Technical Service Bulletin: TSB110305	Released Date: 09-Feb-2012
QST30 New Aftercooler Drain Port

QST30 New Aftercooler Drain Port

Figure 1. Location of drain port on right bank water transfer connector

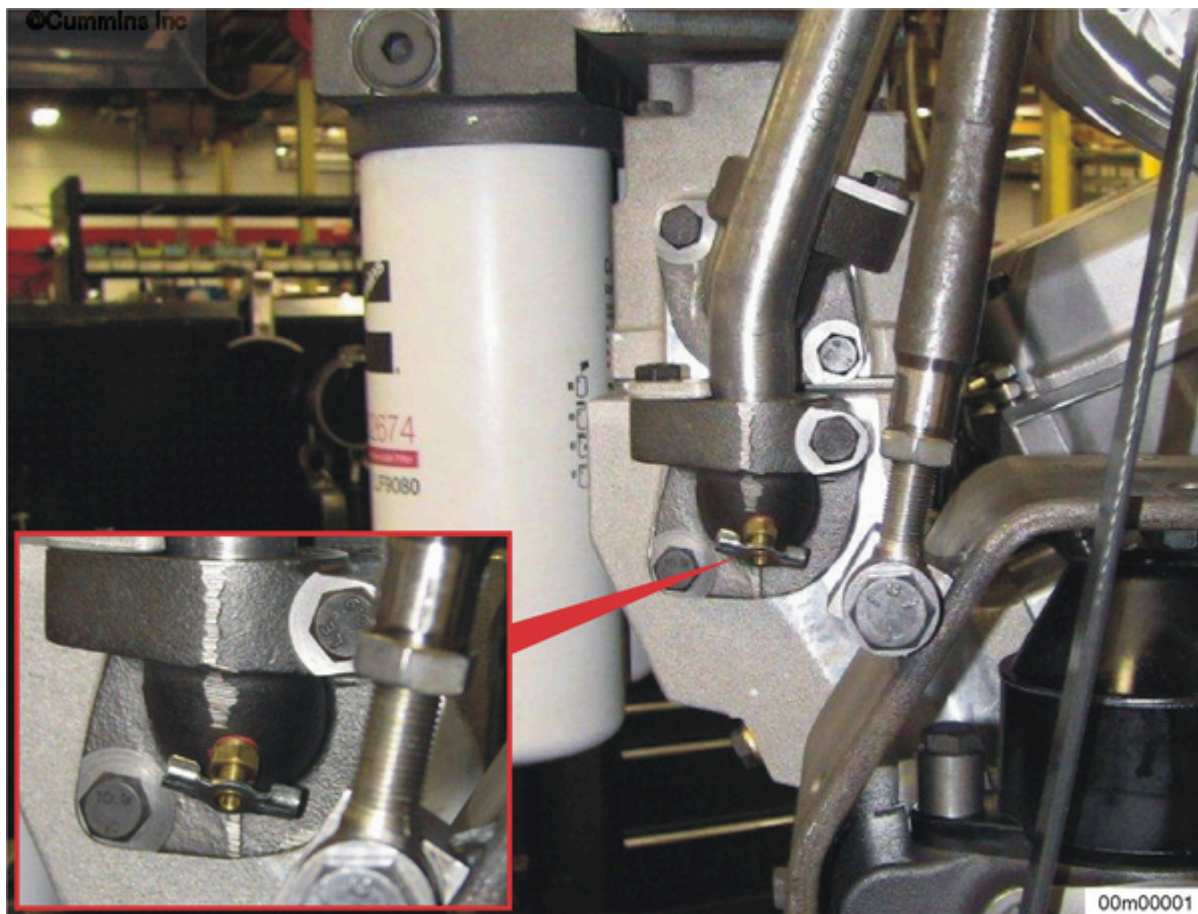
This document announces a change to the right bank water transfer connector for the aftercooler. The affected options are: TB5717, TB5731, and TB5747. These options are **only** used on QST30 engines with auxiliary cooling systems with a two pump two loop design.

The right bank water transfer connectors have been redesigned with drain ports to allow the coolant to be completely drained from the right bank aftercooler core. Initially, the port was added to the existing part numbers, Part Number 3092905 and Part Number 4975564. This began in production on 01 August 2011.

The location of the drain port is shown in **Figure 1**, below.
